C74-6502 PCB Patch Guide (v1.0 Boards)

The following patches were applied to the C74-6502 V1.0 prototype boards during debugging. Patches are divided into three categories:

Patch 1:

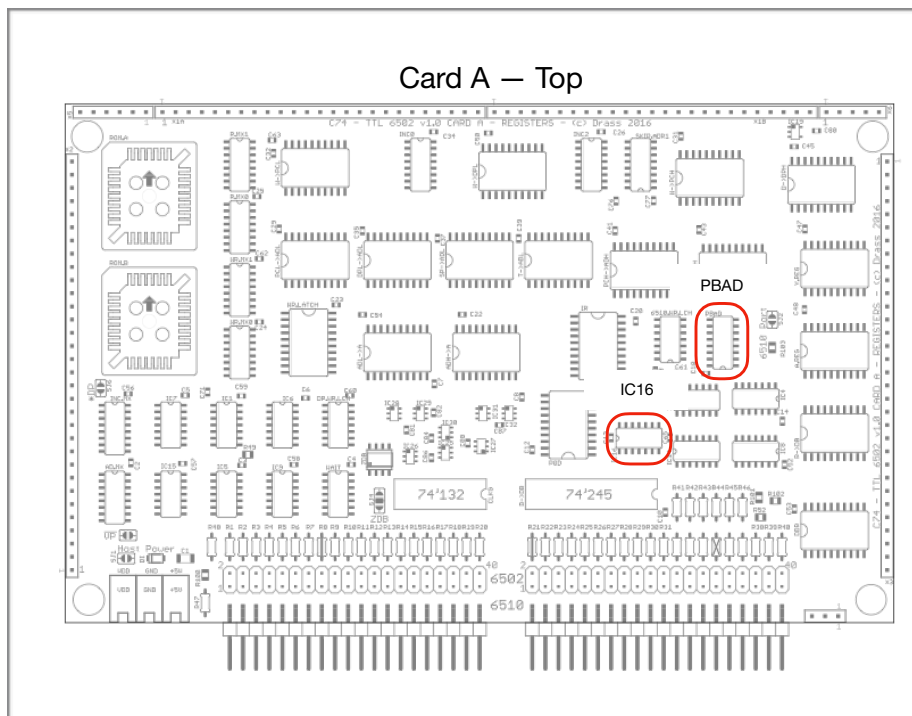
1. 6510 PORT — REVERSED PINS ON PBAD, INVERTED POLARITY OF /BE

Description: The v1.0 boards had certain pins reversed on the PBAD IC (part of the 6510 port). This patch makes the correct connections on PBAD, and skips the inverter on PBAD.5 to have the right polarity.

- Card A: PBAD.11 (LIFT) —> PBAD.10 (PAD)
- Card A: PBAD.10 (LIFT) —> PBAD.11 (PAD)
- Card A: PBAD.7 (LIFT) —> PBAD.9 (PAD)
- Card A: PBAD.9 (LIFT) —> PBAD.7 (PAD)
- Card A: IC16.3 (LIFT)
- Card A: IC16.3 (PAD) —> PBAD.5 (LIFT)

Card A — Bottom

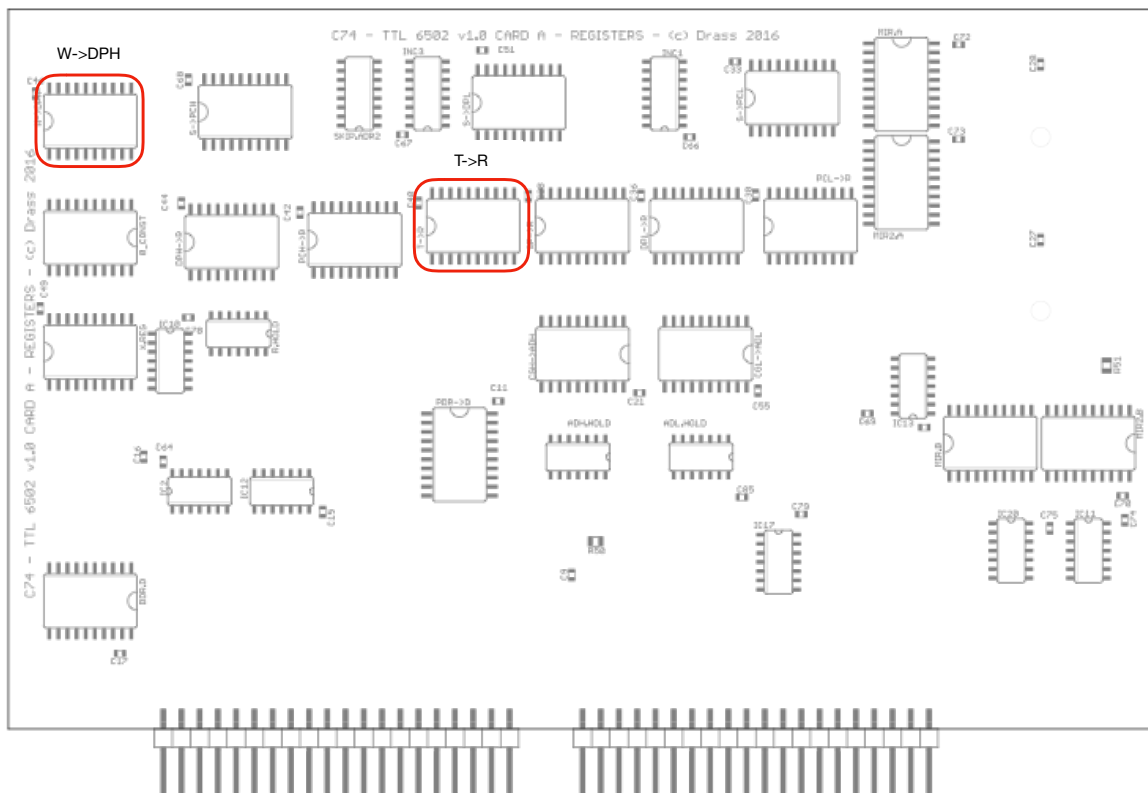
2. T->R INPUTS PINS REVERSED

Description: The v1.0 boards had pins on the T->R buffer reversed. This patch corrects these connections.

- Card A: T->R.7 (PAD) → T->R.6 (LIFT)
- Card A: T->R.8 (PAD) → T->R.7 (LIFT)
- Card A: T->R.9 (PAD) → T->R.8 (LIFT)
- Card A: W->DPH.9 → T->R.9 (LIFT)

Card A — Bottom

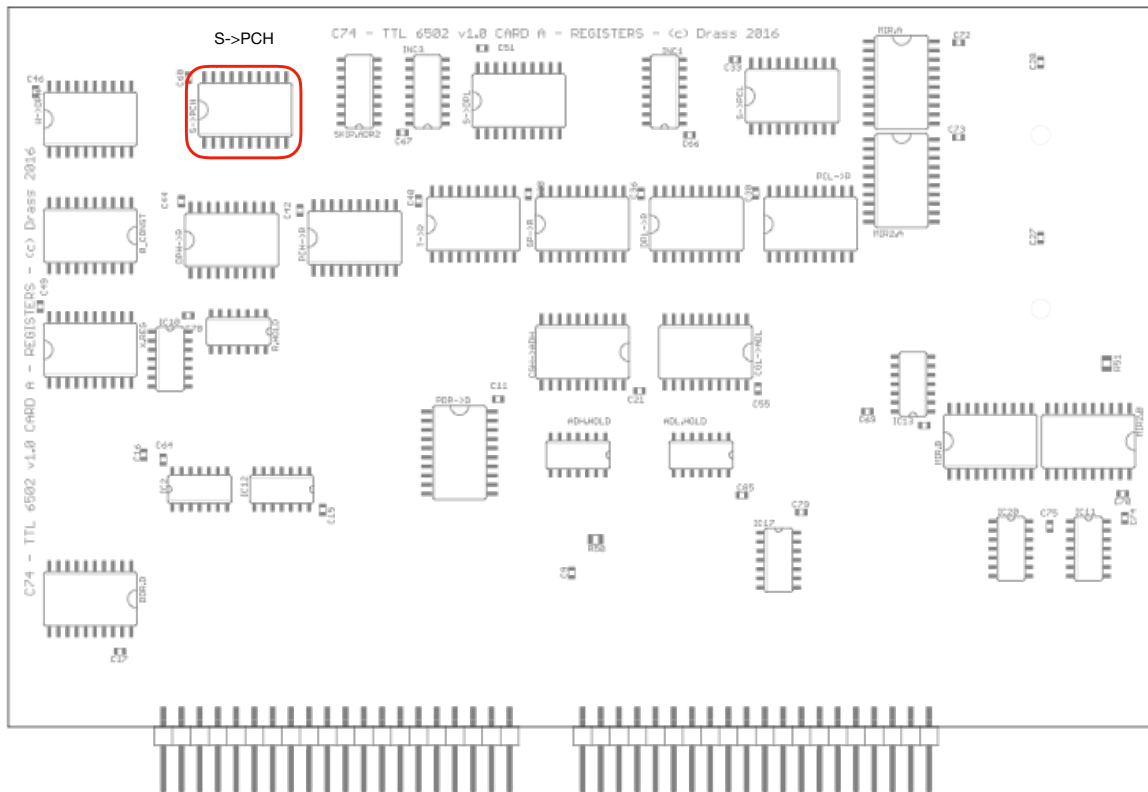
2A. S->PCH OUTPUT PINS REVERSED

Description: The original schematics had pins on the S->PCH buffer reversed. This patch corrects there connections.

- Card A: S->PCH.11 (LIFT) -> S->PCH.18 (PAD)
- Card A: S->PCH.12 (LIFT) -> S->PCH.17 (PAD)
- Card A: S->PCH.13 (LIFT) -> S->PCH.16 (PAD)
- Card A: S->PCH.14 (LIFT) -> S->PCH.15 (PAD)
- Card A: S->PCH.15 (LIFT) -> S->PCH.14 (PAD)
- Card A: S->PCH.16 (LIFT) -> S->PCH.13 (PAD)
- Card A: S->PCH.17 (LIFT) -> S->PCH.12 (PAD)
- Card A: S->PCH.18 (LIFT) -> S->PCH.11 (PAD)

Card B — Bottom

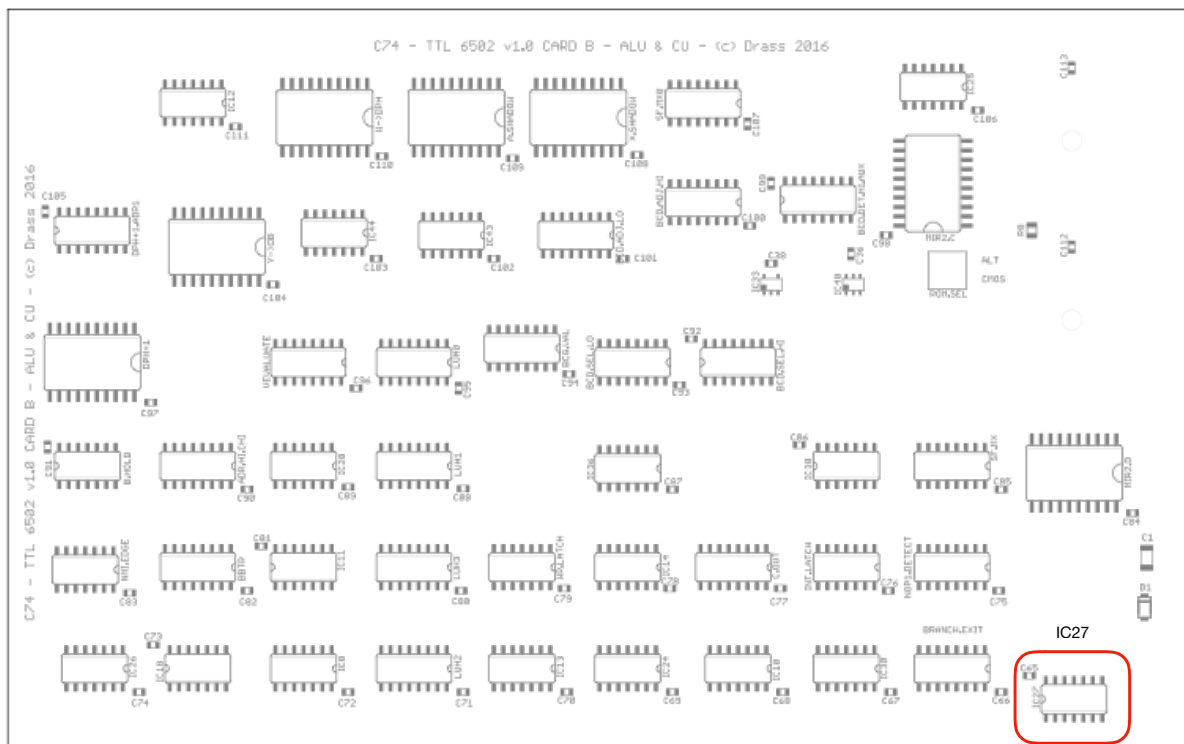
3. 65C02 NOP1 OPCODES

Description: NOP1 opcodes are single cycle NOPs present in the 65C02 instruction set. A bug in the sequencer logic prevented these from being executed properly. Fixing this bug also simplified the sequencer logic and microcode. For that reason, this patch is required for all instruction sets, and must be made for the CPU to work properly. The patch involves jumpers on both the top and bottom of Card B.

- Card B: IC27.14 → IC27.1 (LIFT) [IC27 = silkscreen IC50]

Card A — Bottom

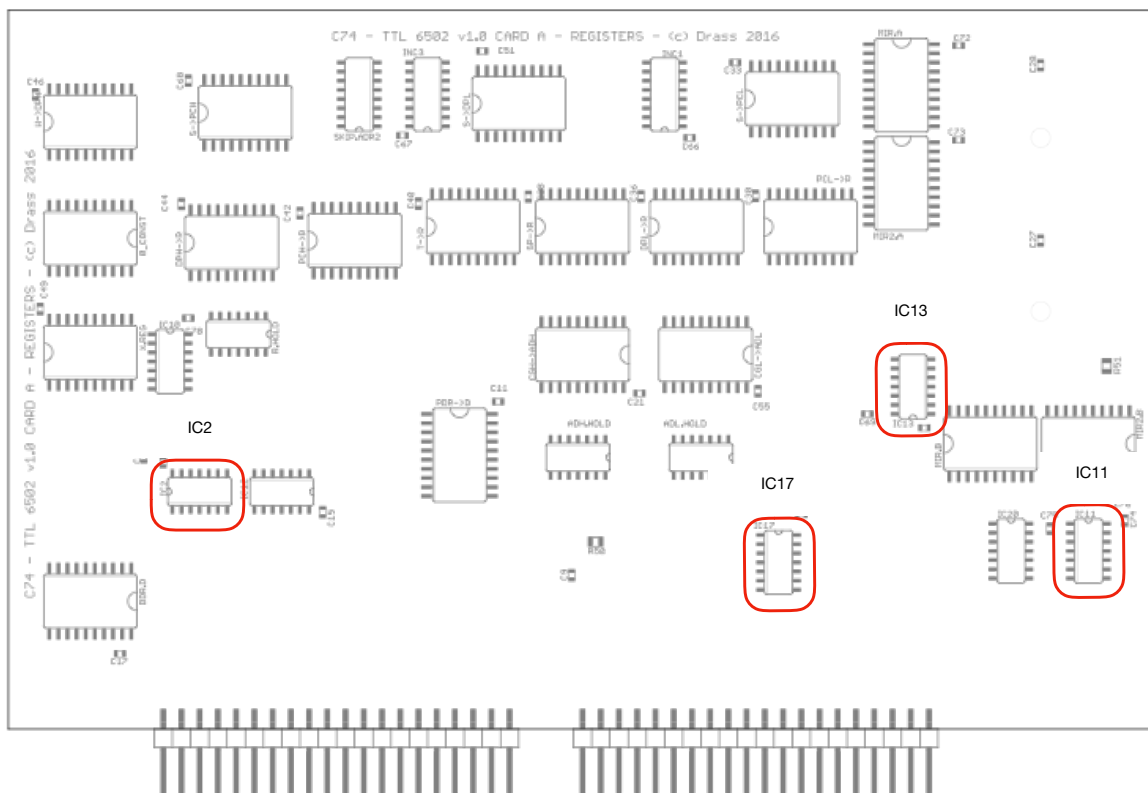
4. R/W TAKES TOO LONG BEYOND 16MHZ

Description: Speed tests revealed that the CPU takes too long to generate R/W when operating above 16MHz. This patch reduces the propagation delay for the R/W signal by taking one gate out of the path.

- Card A: IC11.10 → IC17.9 (LIFT)
- Card A: IC13.3 → IC17.10 (LIFT)
- Card A: IC17.8 → IC2.12
- Card A: IC5.10 (LIFT)

Patch 5:

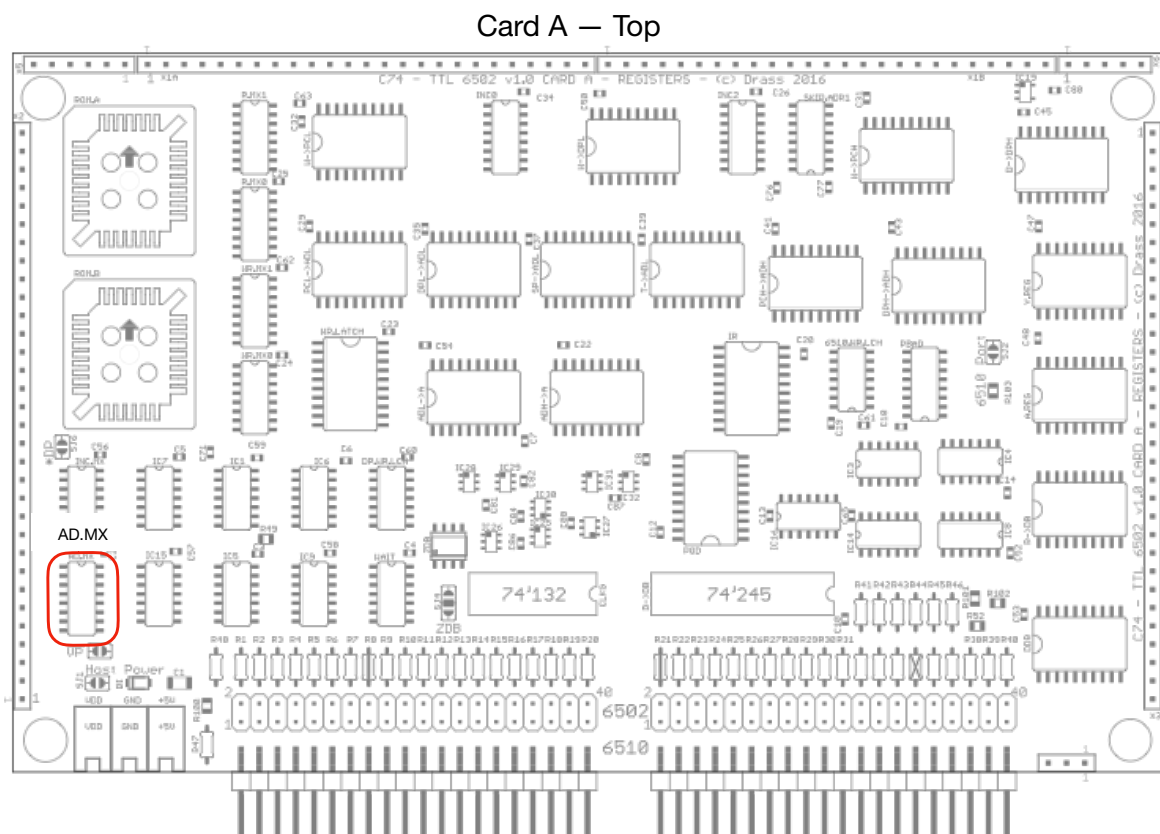
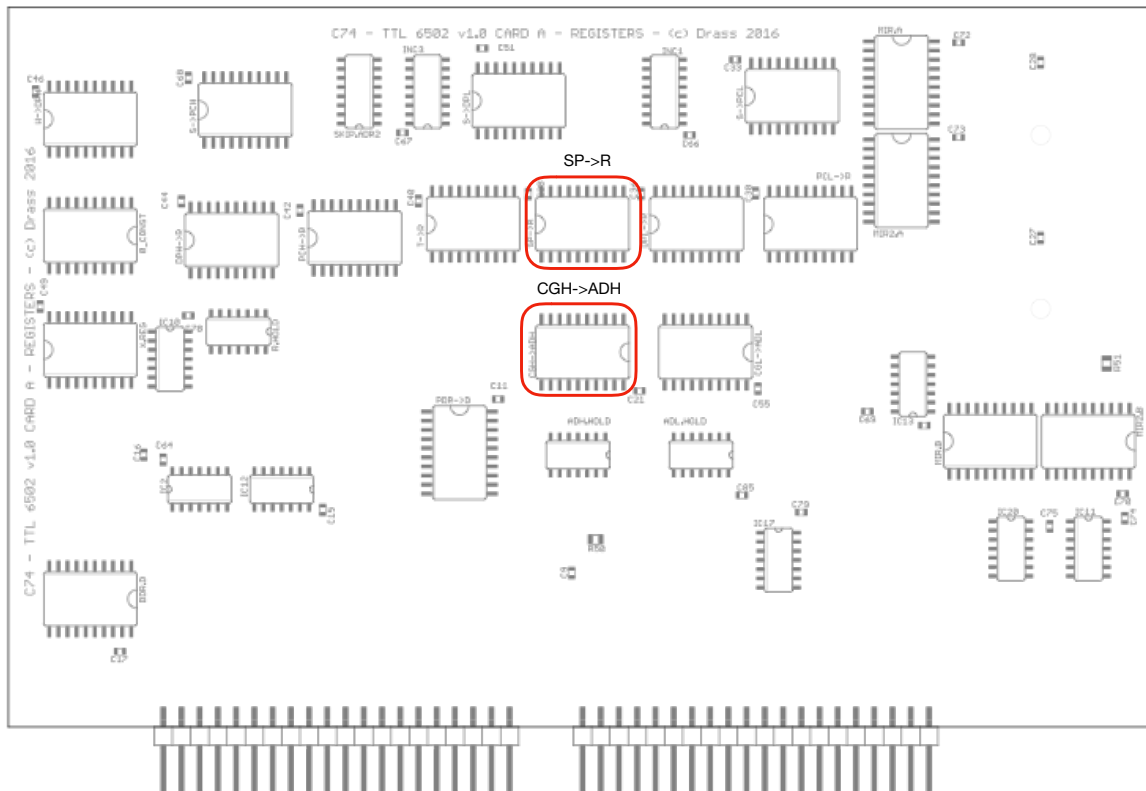
5. COMPATIBILITY WITH BUS SHARING SCHEMES

Description: The C74-6502 was designed to drive the bus during Phase 1 only. This is in order to avoid transient bus collisions at high speeds. Unfortunately, this bus scheme is not compatible with systems where the CPU shares control of the bus with other peripherals (such as on the Commodore 64 and others). This patch will cause the CPU to drive the bus during Phase 2 as well as Phase 1. This will lead to short transient collisions on the bus during state transitions, but these are benign and can be safely ignored.

- Card A: AD.MX.5 → AD.MX.4 (LIFT)
- Card A: SP→R.10 → CGH→ADH.1 (LIFT)

Patch 6:

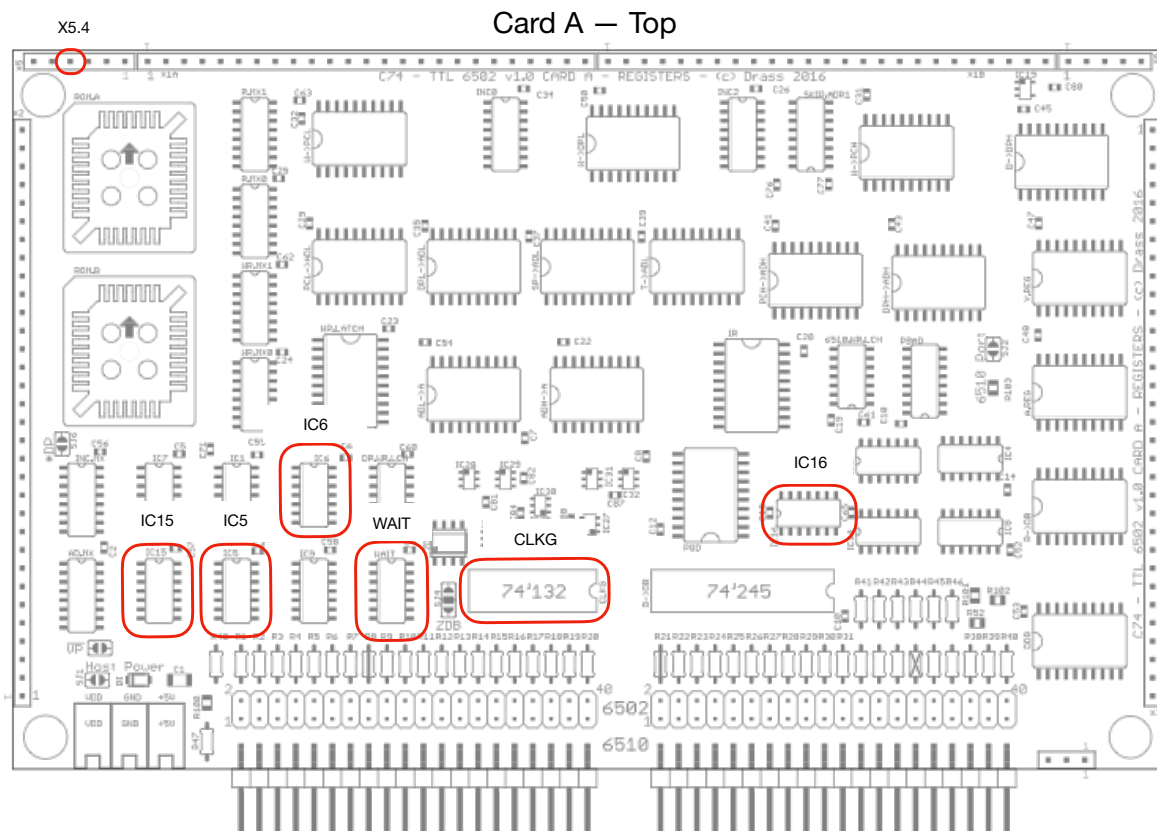
6. RDY TAKES EFFECT ONE CYCLE TOO LATE AND RDY NMOS 6502 COMPATIBILITY

Description: The RDY signal is meant to pause the CPU during Phase 2 of the cycle in which it is detected. Instead, the TTL CPU was pausing during Phase 1 of the following cycle. In addition, RDY should not pause the CPU on reads when emulating the NMOS 6502 but should do so for the 65C02. This patch will cause the RDY to correctly pause the CPU during Phase 1, and its behaviour will adjust automatically based on the active instruction-set.

- Card A: CLKG.4 → CLKG.5 (LIFT)
- Card A: CLKG.5 (SOCKET) → WAIT.2 (LIFT)
- Card A: CLKG.6 → IC6.9 (LIFT)
- Card A: IC6.11 → IC6.10 (LIFT)
- Card A: X5.4 → IC16.3 (LIFT)
- Card A: IC16.4 → IC6.12 (LIFT)
- Card A: IC15.12 → IC6.13 (LIFT)
- Card A: IC6.8 → WAIT.10 (LIFT)
- Card A: WAIT.4 → WAIT.1 (LIFT)
- Card A: WAIT.6 (LIFT)
- Card A: WAIT.5 → WAIT.6 (PAD)
-

Patch 7: Part 1

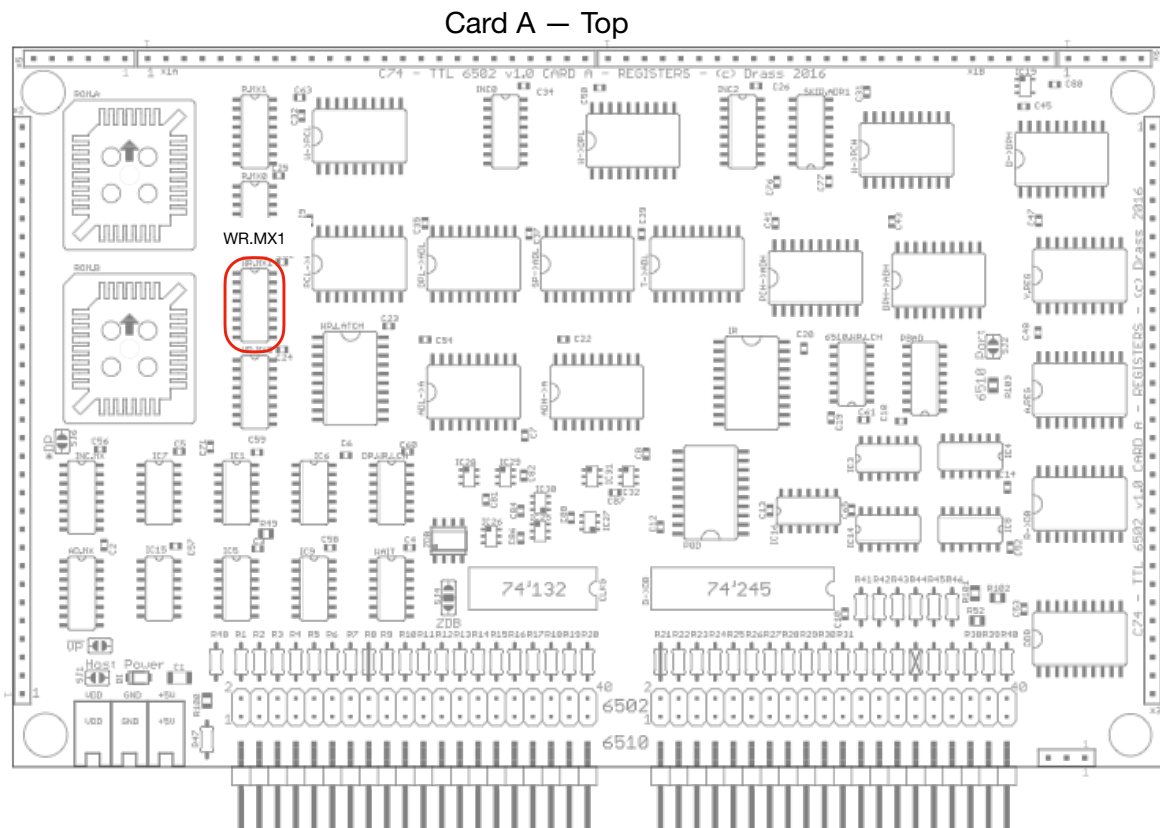
7. NMOS 6502 MODIFY CYCLE WRITE

Description: The NMOS 6502 performs a Read-Write-Write sequence for RMW instructions (INC, DEC, ASL, etc.). The C74-6502 was designed to duplicate the 65C02 behaviour, which is Read-Read-Write. This patch will cause a Write to be performed during the Modify (middle) cycle when the NMOS 6502 instruction-set is selected.

- Card A: WR.MX1.9 (LIFT)

Card A — Bottom

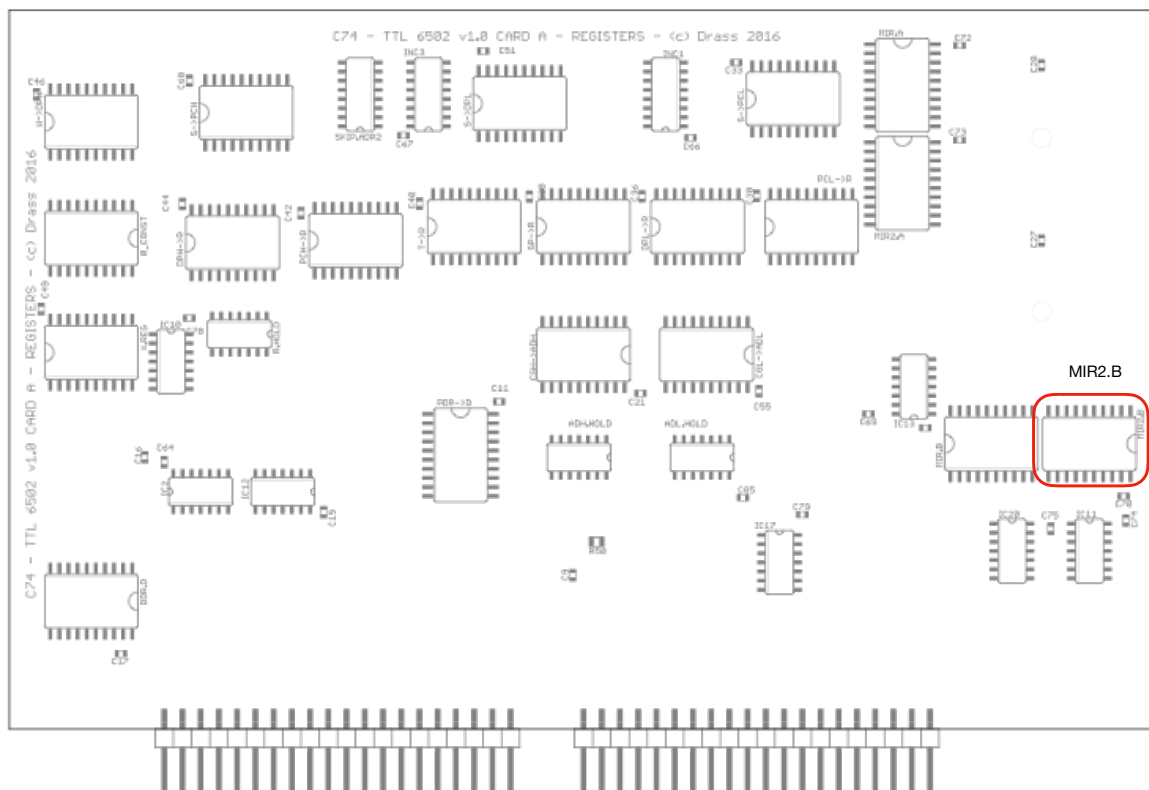
8. DEAD-CYCLE — NMOS VS. CMOS COMPATIBLE BEHAVIOUR

Description: The NMOS 6502 produces partial addresses on the bus during address calculation. This was changed on the 65C02, which leaves in place the Previous Bus Address in those situations. This patch enables the “*DP” jumper to select between these two behaviours, leaving the jumper open for NMOS compatible operation, and closing it for CMOS operation.

- Card A: MIR2.B.3 —> MIR2.B.6 (LIFT)
- Card A: MIR2.B.6 (PAD) —> MIR2.B.7 (LIFT)

Patch 9: Part 1

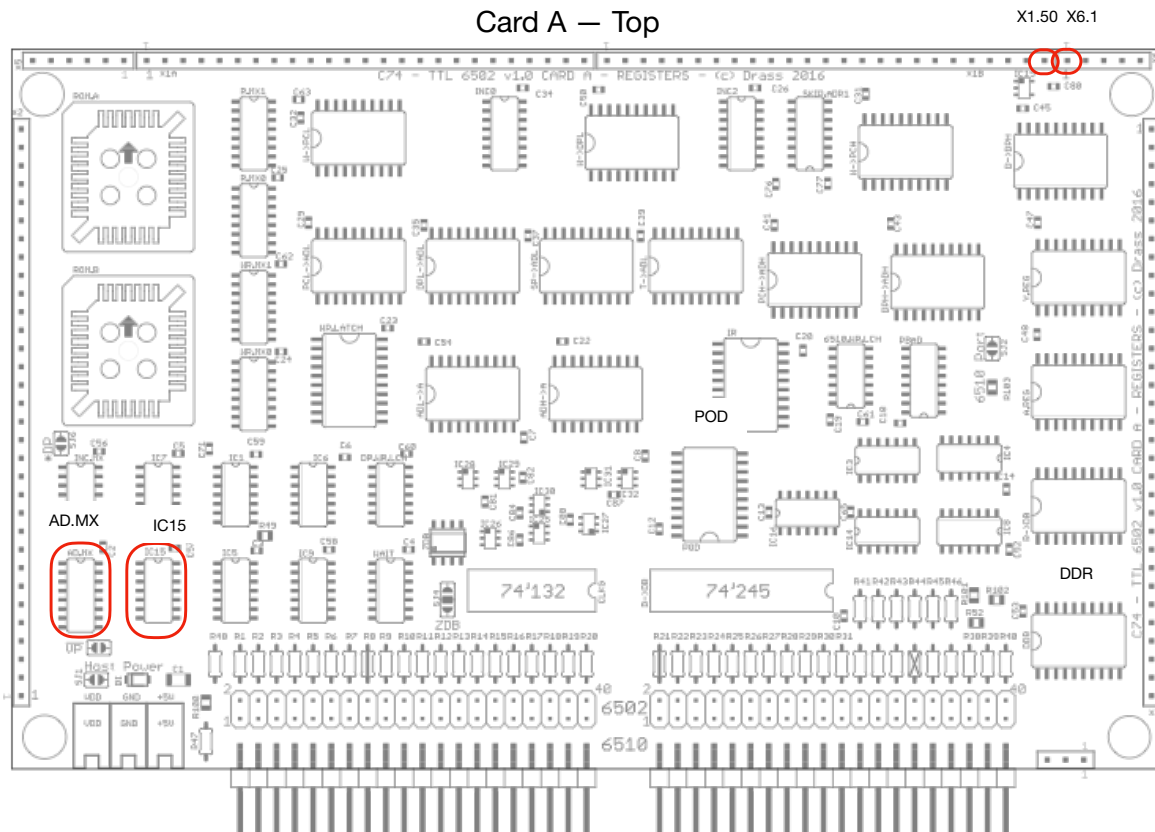
9. NMI INCORRECTLY INTERRUPTS IRQ

Description: This patch fixes a bug where the CPU will loose an IRQ if an NMI happens to arrive just as the IRQ vector is being fetched by the CPU.

- Card A: AD.MX.7 → X1.50
- Card A: IC15.1 → IC15.13 (LIFT)
- Card A: X6.1 → POD.1 (LIFT) → DDR.1
